ADDISON EXPRESS HANGER ADDITION
4500 Claire Chennault
Addison, Texas

PLAN VIEW
CONTOURS & DRAINAGE PLAN

G-2

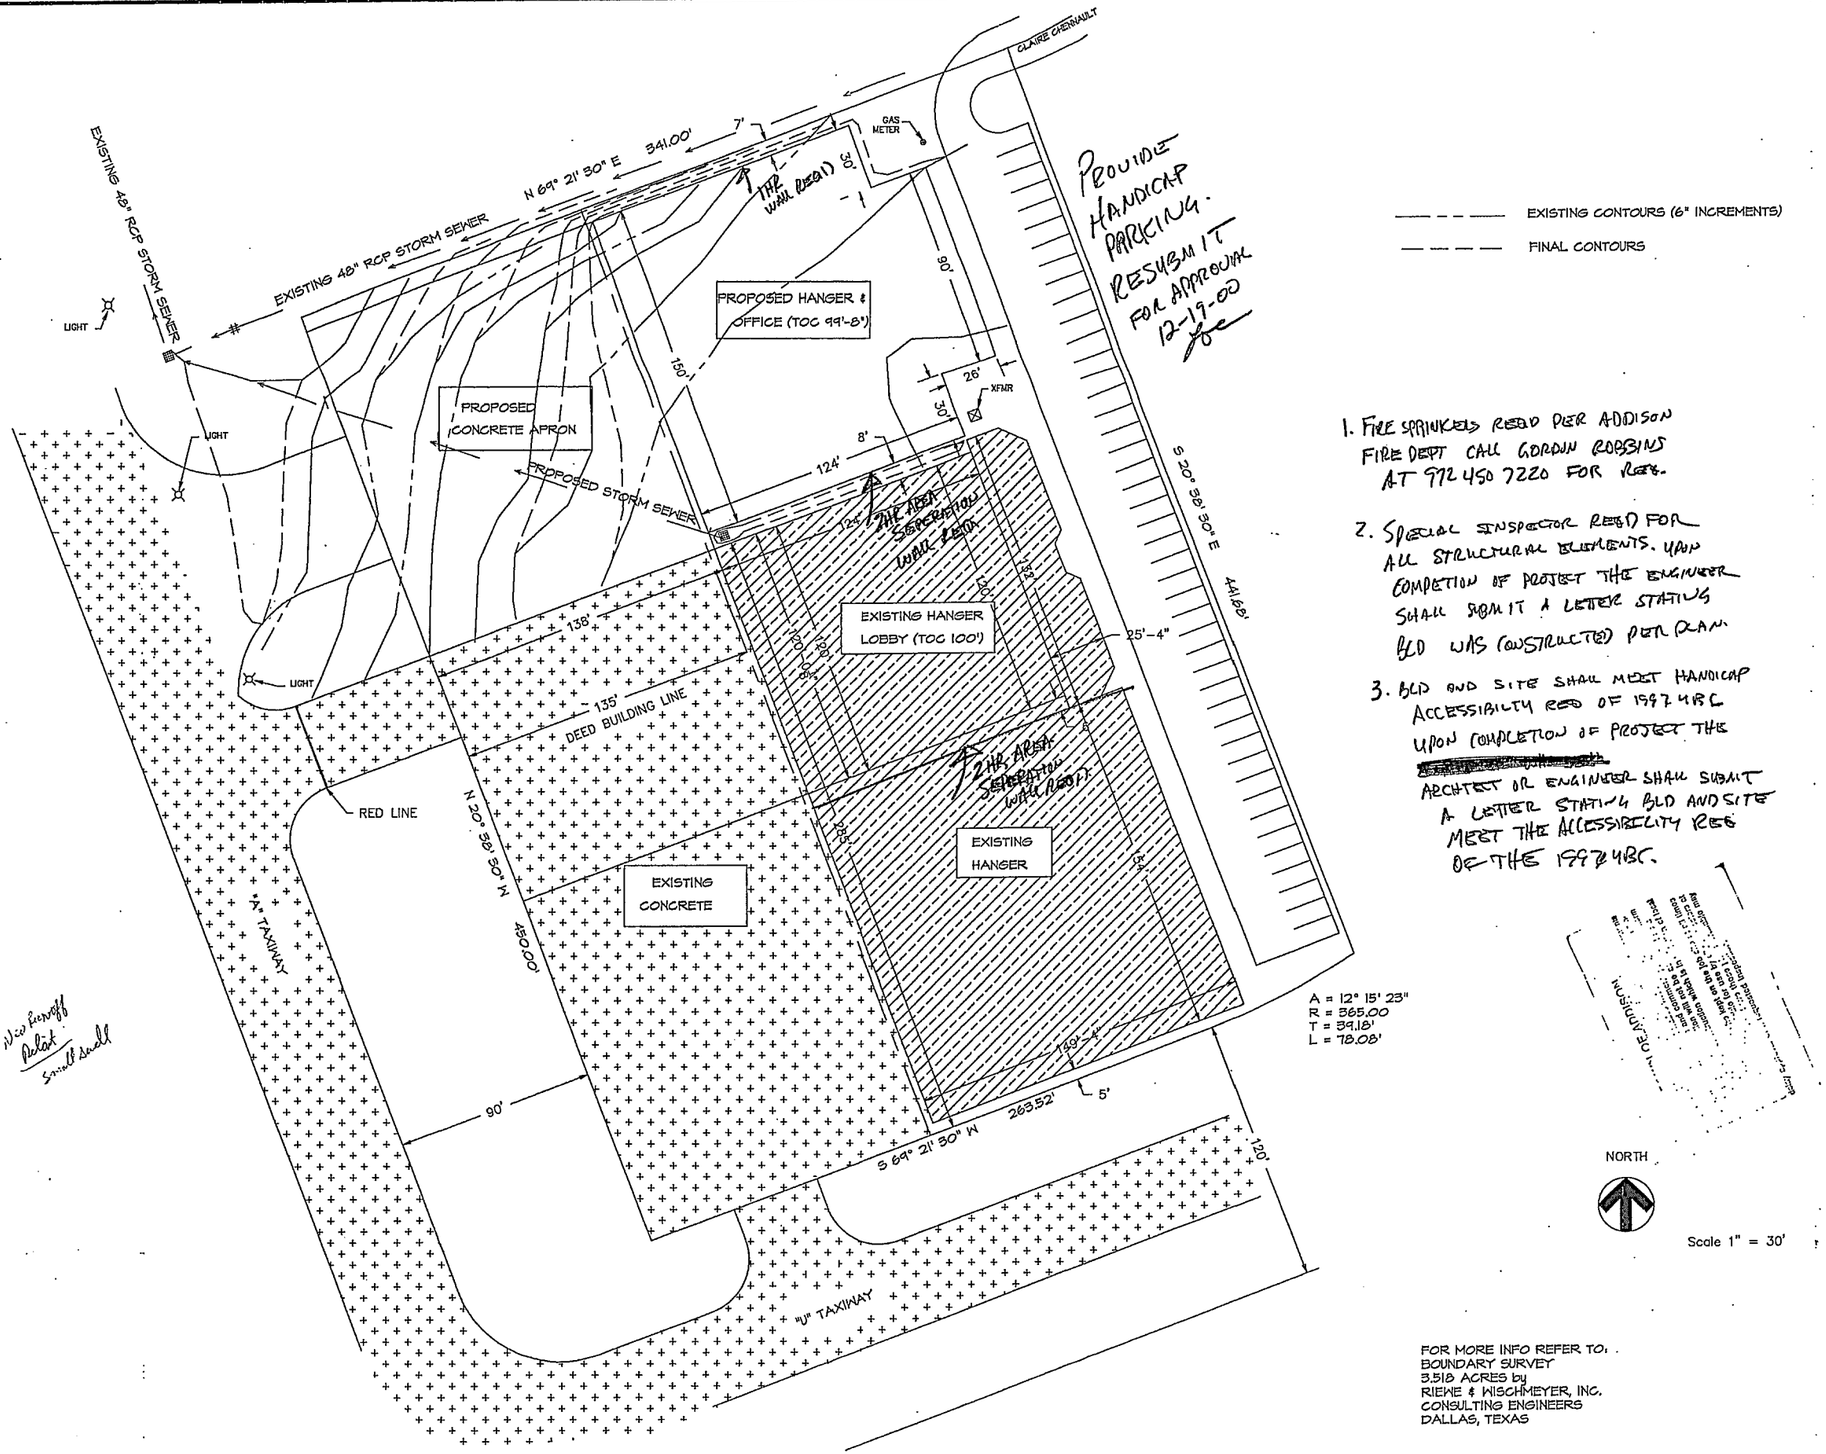
Provide Handicap parking. Resubmit for approval 12-19-00

1. Fire sprinklers reqd per Addison Fire Dept call Gordon Robbins at 972 450 7220 for req.
2. Special inspector reqd for all structural elements. Upon completion of project the engineer shall submit a letter stating bld was constructed per plan.
3. Bld and site shall meet handicap accessibility req of 1997 UBC. Upon completion of project the architect or engineer shall submit a letter stating bld and site meet the accessibility req of the 1997 UBC.
